Ref: **A1461 North Hykeham Relief Road Compulsory Purchase Order 2024**

The Lincolnshire County Council (A1461 North Hykeham Relief Road) Compulsory Purchase Order 2024 ("CPO")

Your client: Mrs S Burgess

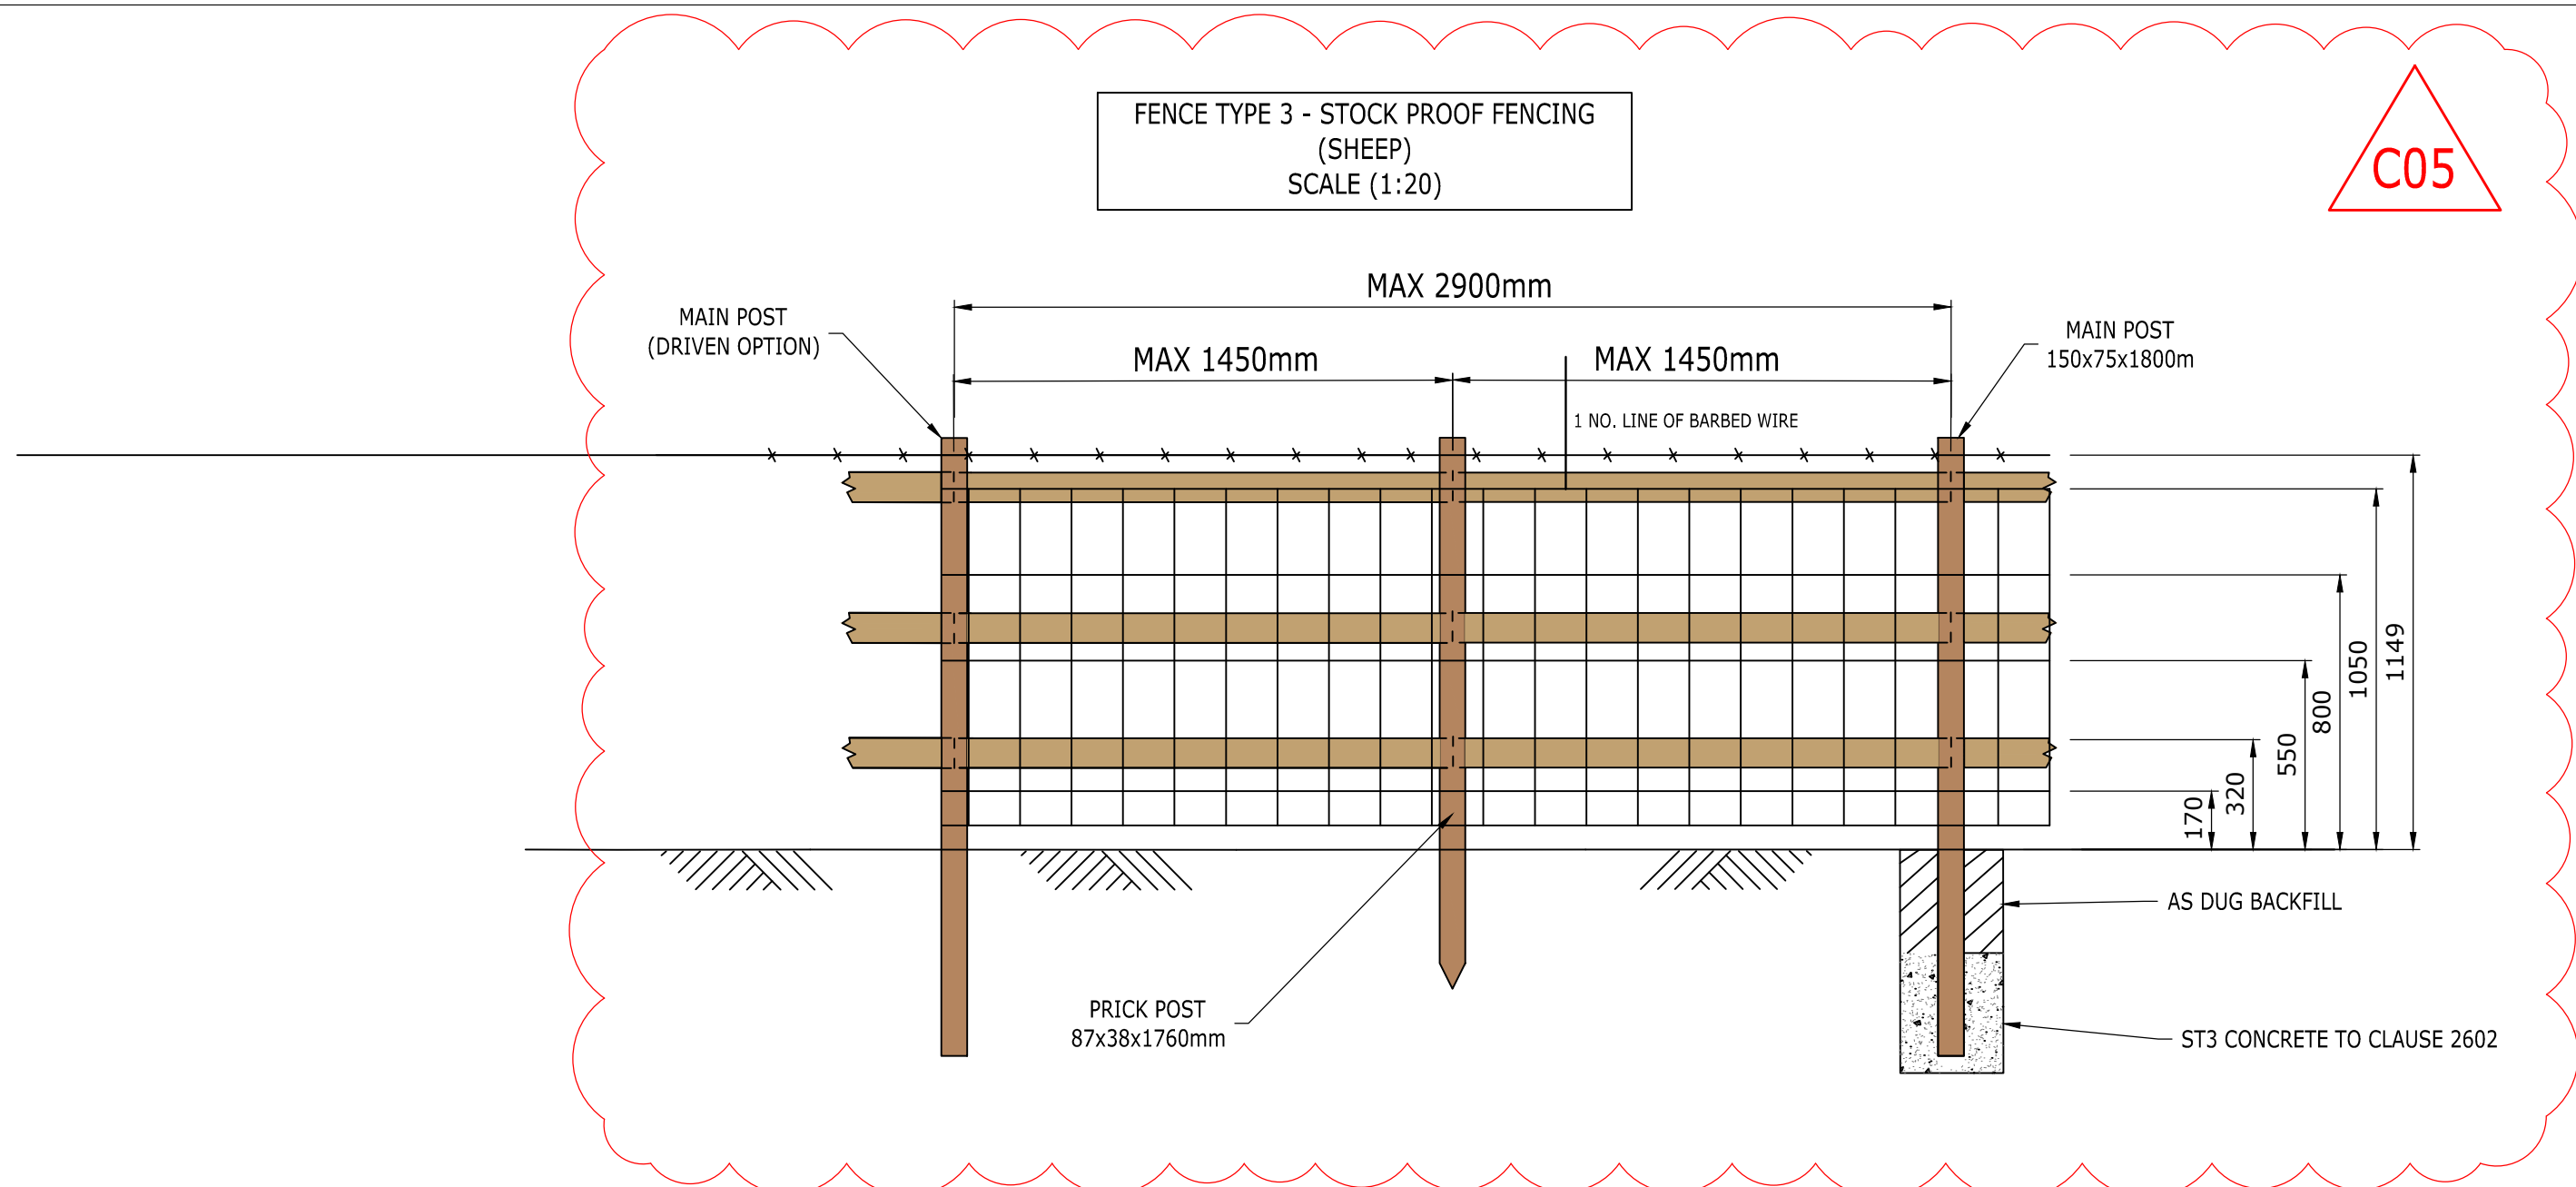
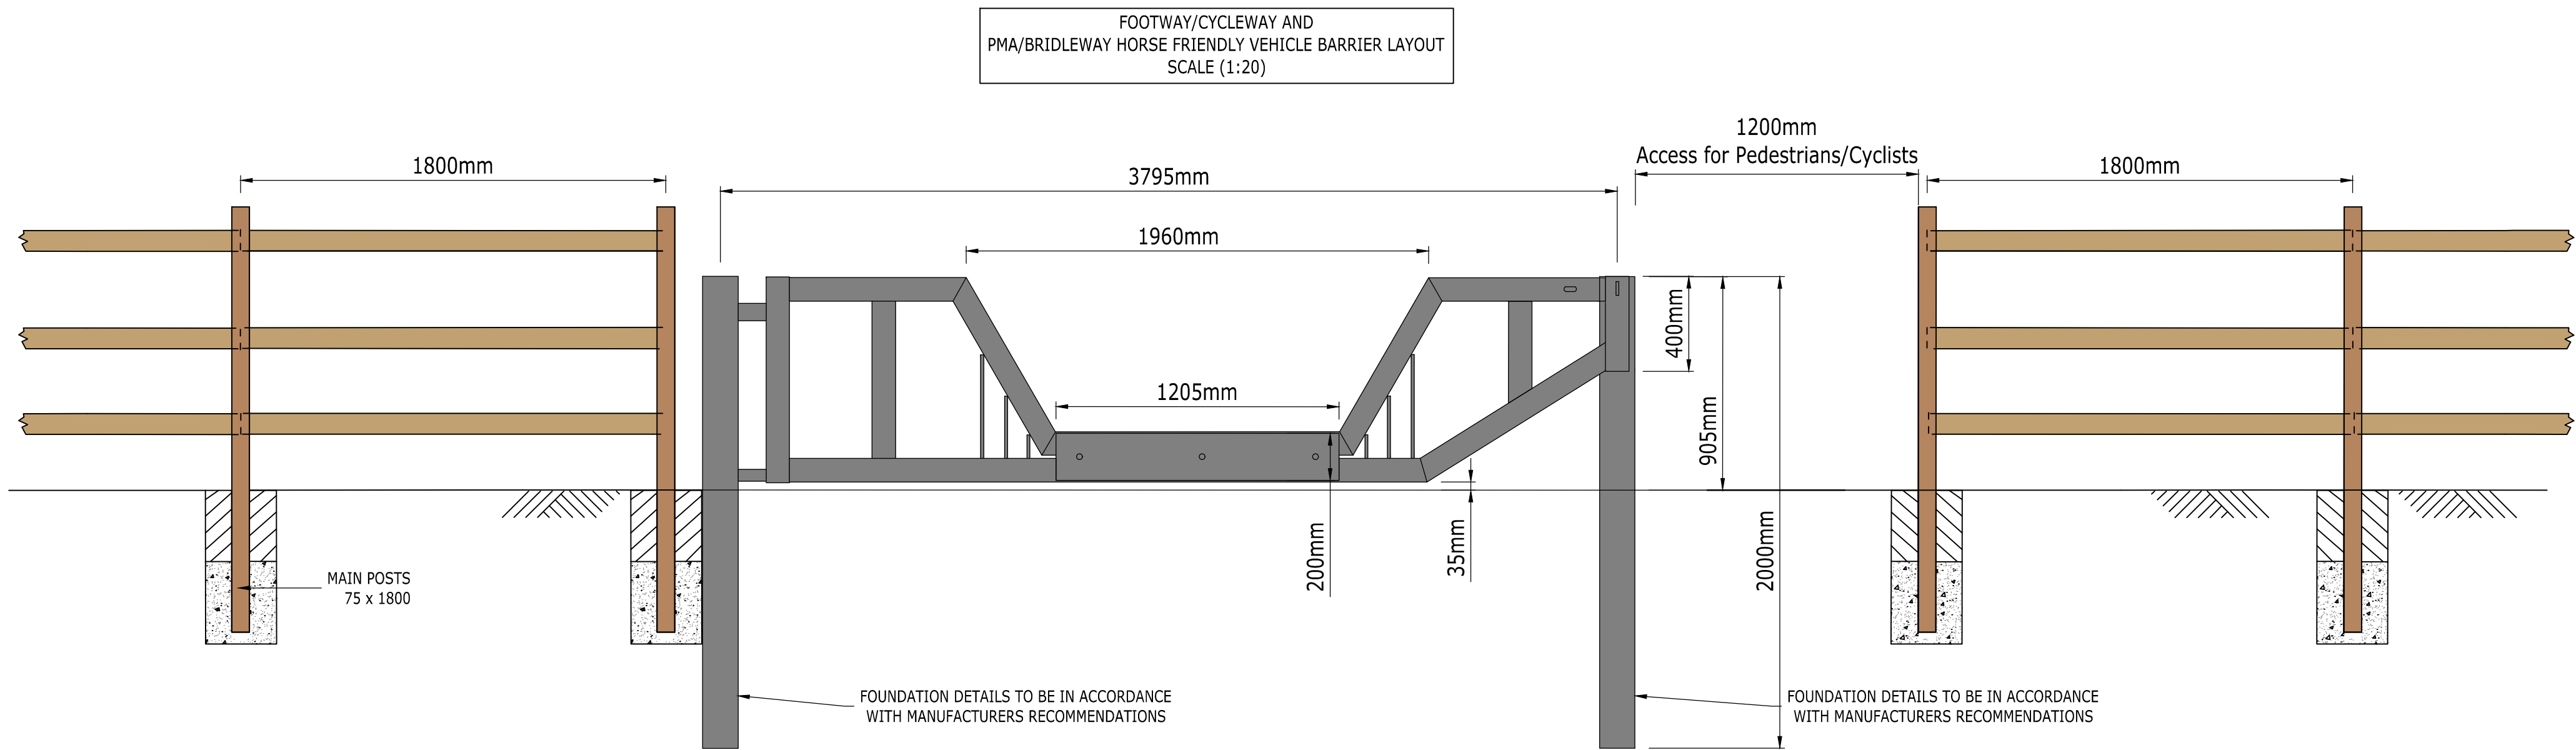
1. Your first concern is that the 'bat tunnel' adjoining plot 216 is a missed opportunity in respect of safety and access and that if the tunnel were enlarged to accommodate tractors and trailers it would remove the majority of farm traffic from the public highway.
 - 1.1. The 'bat tunnel' is 4m x 4m box culvert with a headroom of 3.5m as shown in the section below.

The arrangement of the culvert is such because the culvert serves a dual function, being essential mitigation for the impact of the Scheme in the population of barbastelle bats and forming part of the drainage strategy for the Scheme.

- 1.4. The 'bat tunnel' has been designed to fulfil this dual function and has been granted planning permission in the form that it is.
 - 1.5. Amendments to the approved design would require additional approvals and would be more expensive.

NHRR-RAM-HGN-HYKE-DE-CH-0 Rev C05 Series 300 Standard Details Fencing Sheet 2 – Fence Type 4 for Stock Proof Fencing (Cattle)

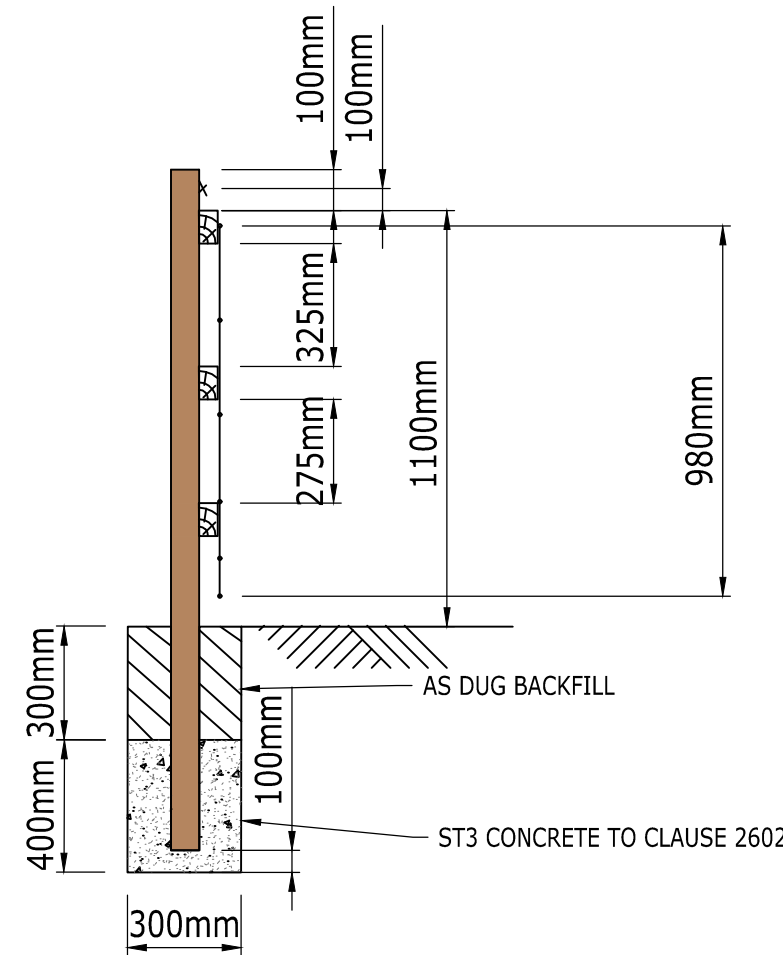
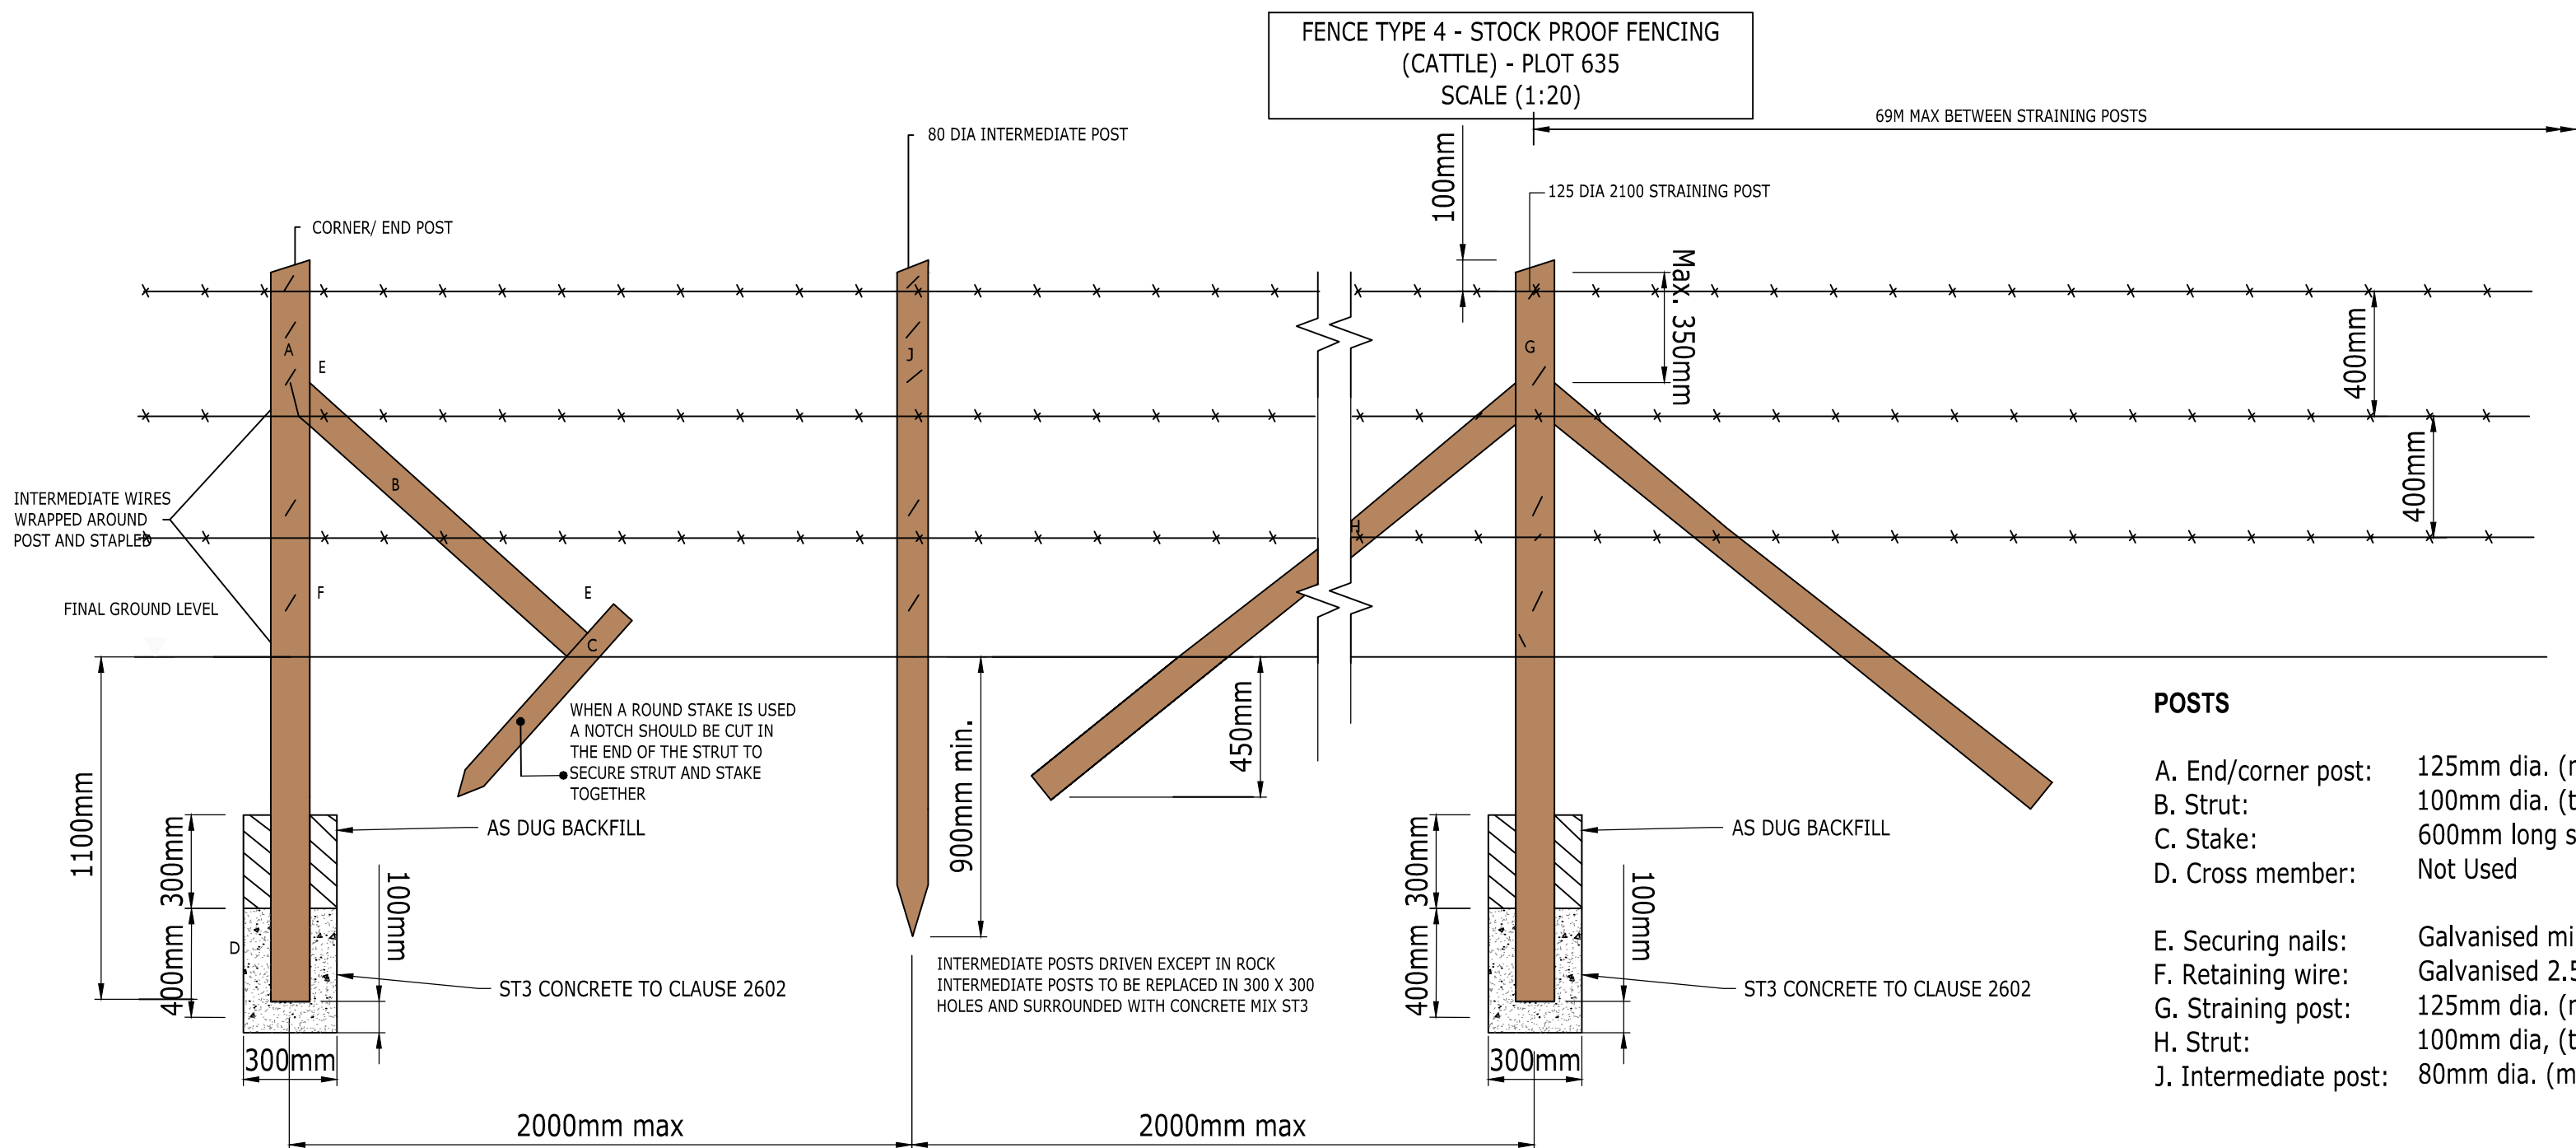
- b. Fencing details have been discussed but no undertaking has been supplied with regard to the fencing or who will be responsible for its maintenance post construction.

- b. Stockproof fencing will be provided in the locations discussed in accordance with the fencing drawing at Appendix A.
 - c. There are ongoing discussions about the hedgerows and tracks within the farm holding.
